PCI DESIGN HANDBOOK

8TH EDITION ERRATA

PCI Design Handbook

Eighth Edition Errata

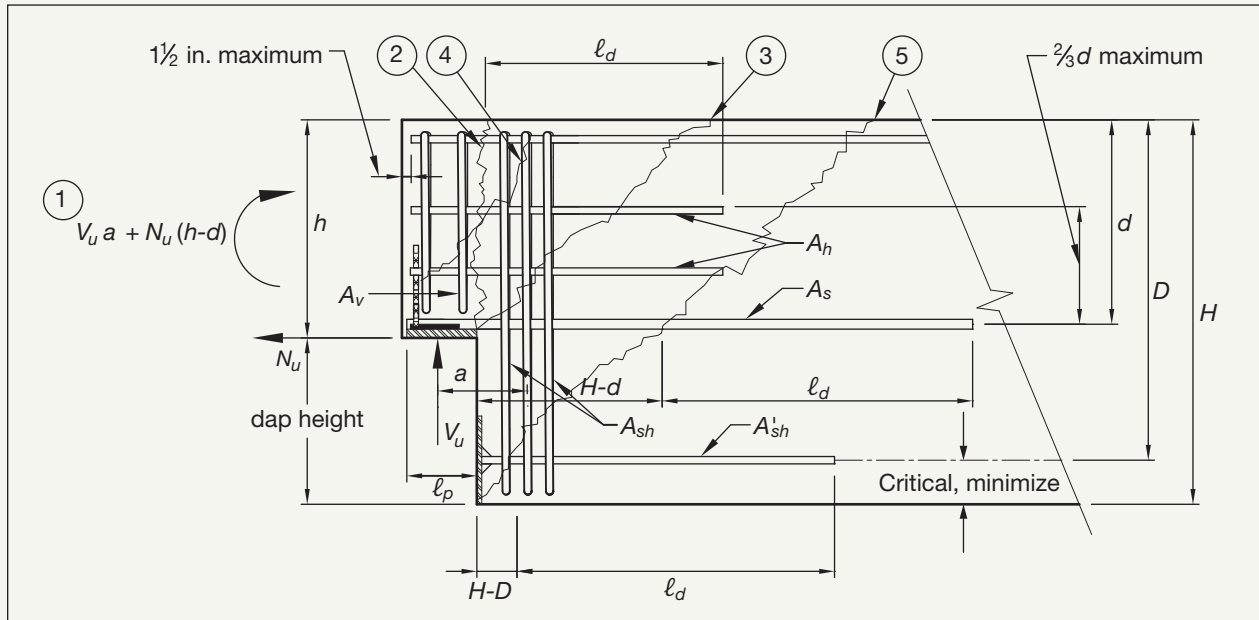
Page 5–76, Figure 5.5.3, top figure: Replace figure with the following to remove “Center of gravity of flexural reinforcement” and associated leader line at bottom of figure and to add “Critical, minimize” and associated dimension lines:

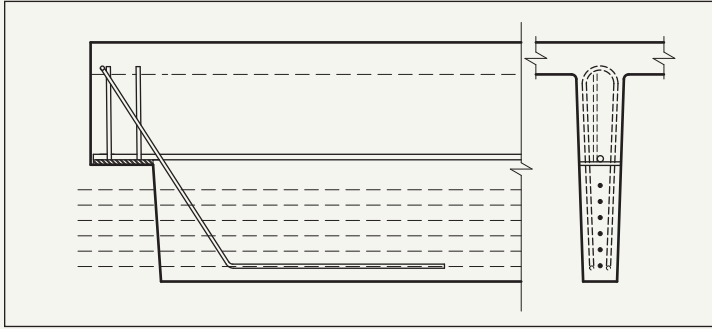
Page 5–77, Figure 5.5.4 (b): Replace figure with the following to delete the dowel bar and vertical plate at the bearing angle:

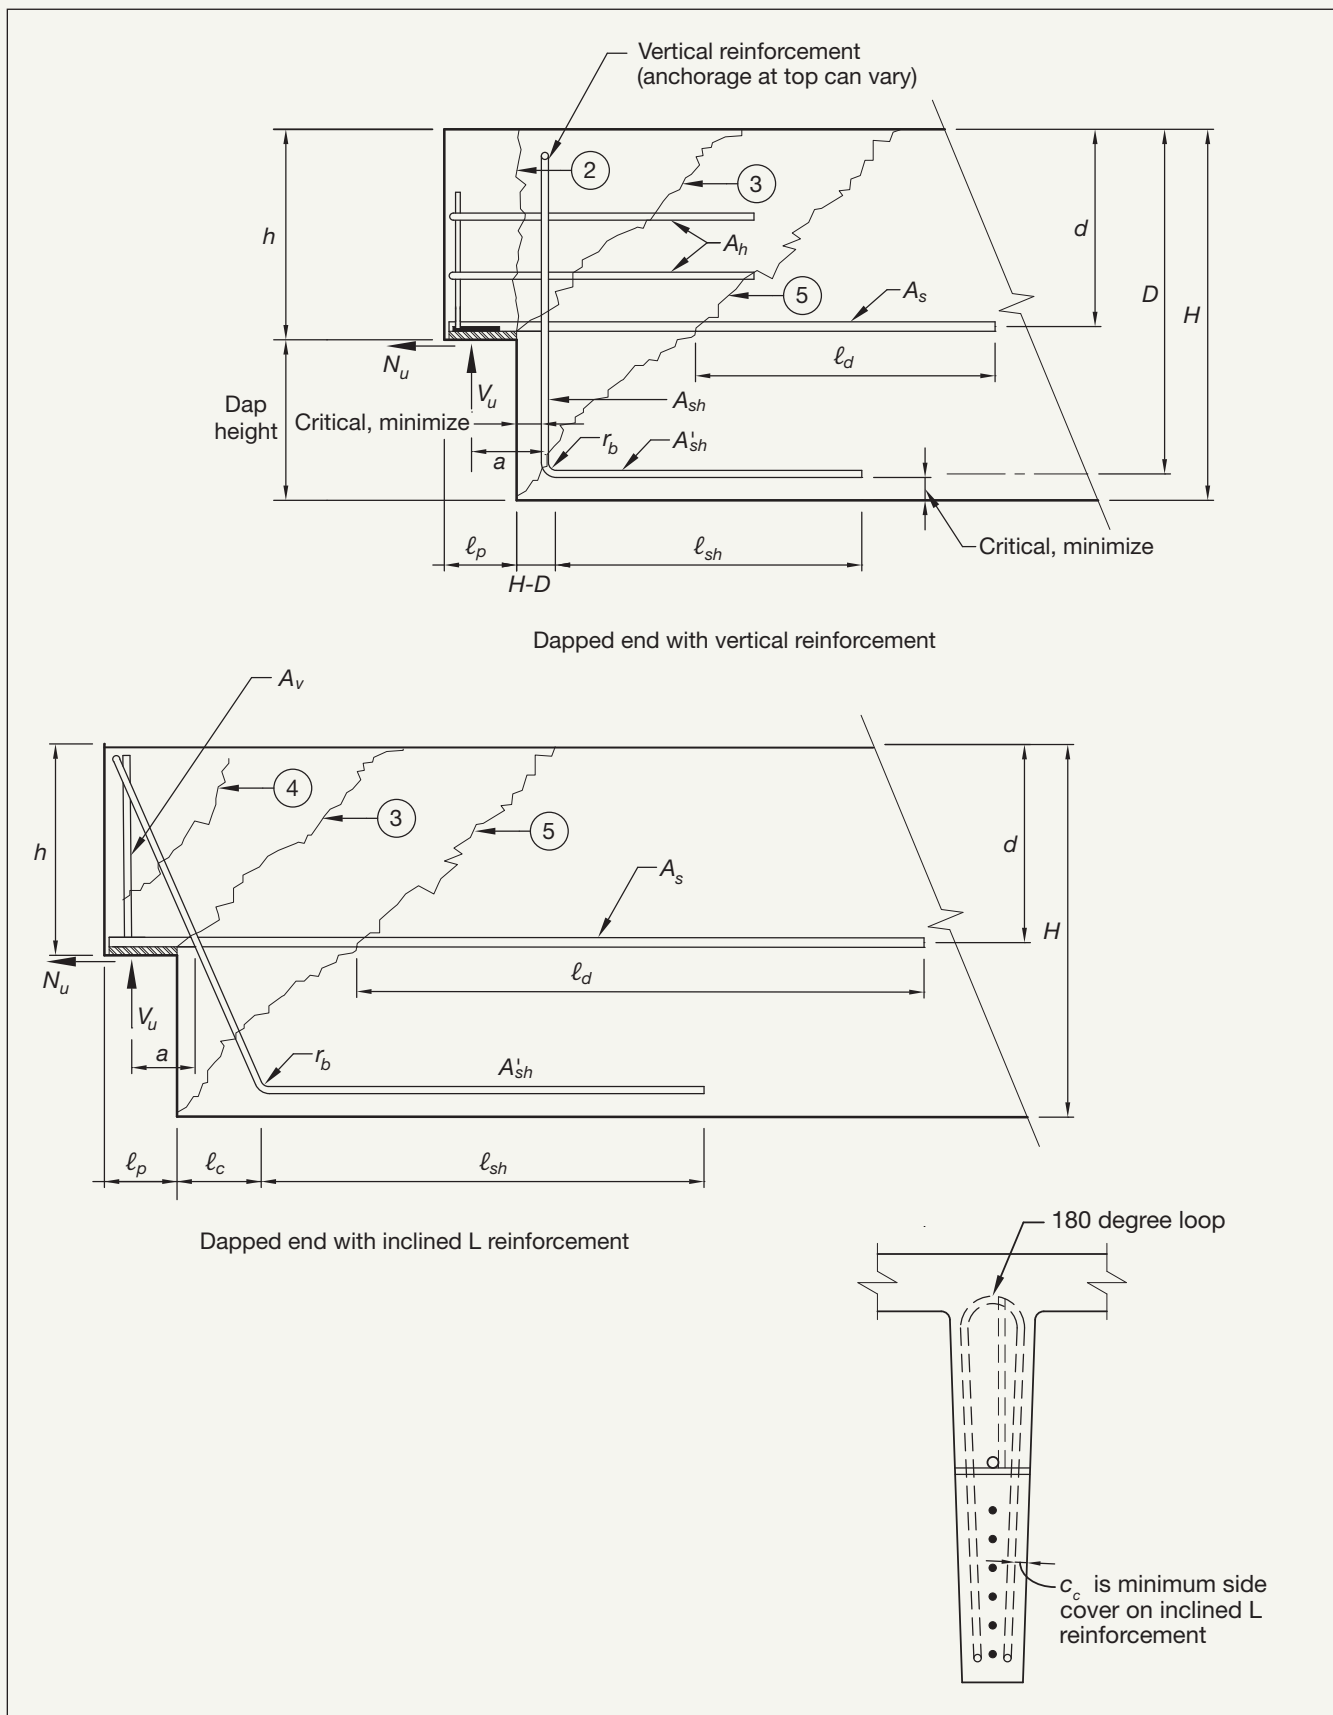
Page 5-78, Figure 5.5.5: Replace figures with the following. Changes include adding the vertical crack 2 on the top and crack numbers on the bottom figure, revising the length of the A_s on the bottom figure, and deleting the $2h$ dimension line and A_h on the section:

Page 5–78, Figure 5.5.5: Add the following note to figure: “Note: See Eq. 5-73, 5-74, and 5-75 for limits on the shear strength for a distance of $2H$ beyond the dap.”

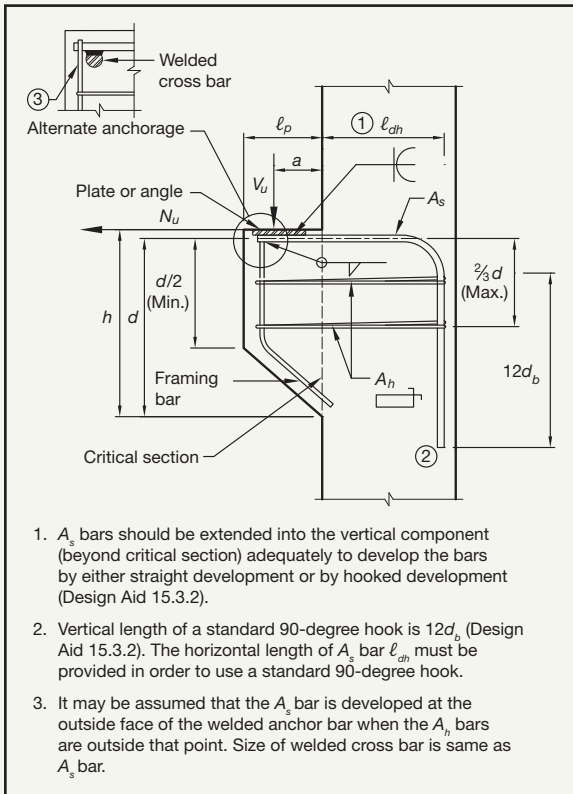
Page 5-99, Figure 5.7.1: Replace figure with the following. Change revises minimum $d/2$ dimension at face of corbel to extend from bearing surface of corbel rather than from centroid of primary reinforcement in agreement with ACI 318-14 Section 16.5.2.2 and Figure R16.5.1a. Change also revises Note 1 to replace “Design Aid 15.4.4” with “Design Aid 15.3.2”.

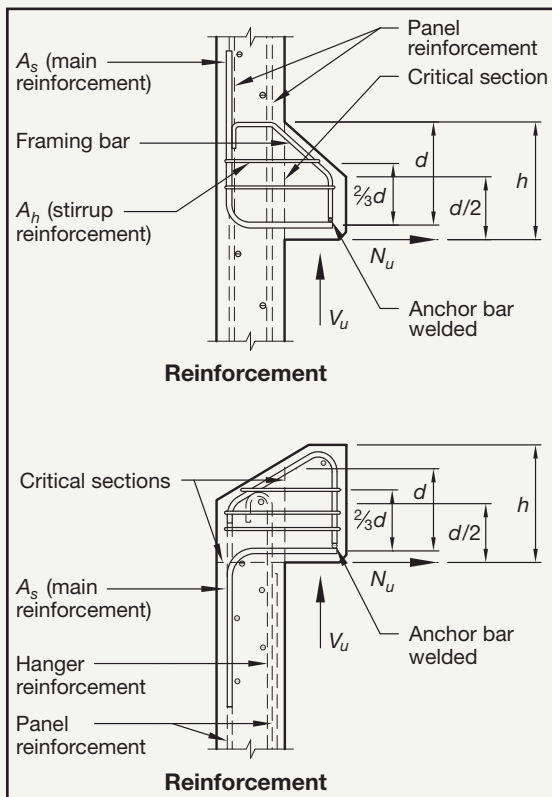
Page 5-101, Figure 5.7.2: Replace figure with the following. Change replaces $h/2$ dimension at the face of the corbel with $d/2$.

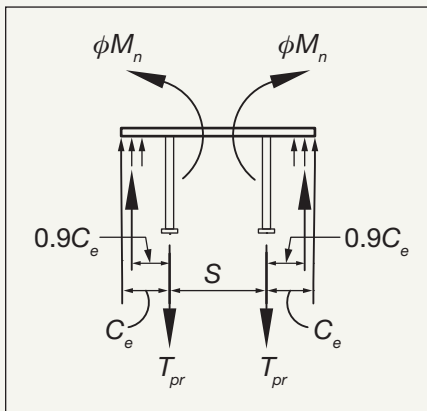
Page 6–19, Example 6.5.2.1: Replace figure on the left with the following:

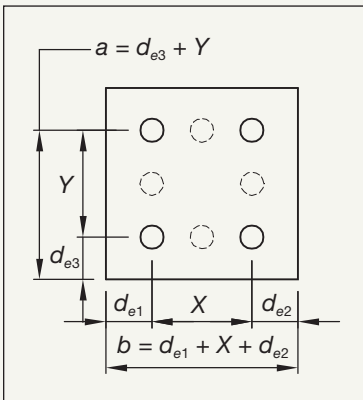
Page 6–122, Design Aid 6.15.11, Case 6: Replace figure with the following:
